This document contains suggested enhancements to the Advanced Library Format, using ALF 2.0 as baseline. The document serves as a worksheet rather than a formal proposal. The suggested enhancements are collected in no particular order. The idea is to keep track of evolving proposals here and then agree formally whether or not they should be part of the IEEE spec.

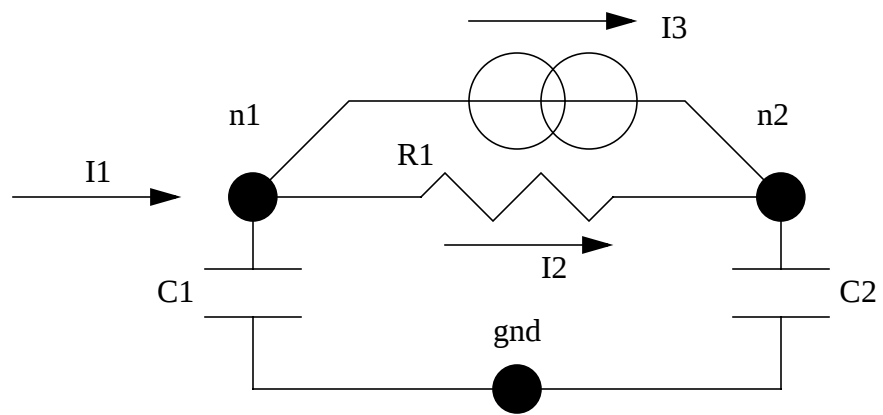
In the context of WIRE, the following annotations for CURRENT shall be legal:

COMPONENT = *component_identifier* ;

Current flows through the component. The component must be a declared two-terminal electrical component in the context of the WIRE, i.e. a RESISTANCE, CAPACITANCE, VOLTAGE or INDUCTANCE (excluding mutual inductance, which has 4 terminals). The direction of the current flow is given by the order of node identifiers in the NODE annotation for that component (see ALF 2.0, chapter 8.15.3, 8.15.4).

NODE { *1st_node_identifier* *2nd_node_identifier* }

Current flows through a current source connected between the nodes. The direction of the current flow is given by the order of node identifiers in this NODE annotation.
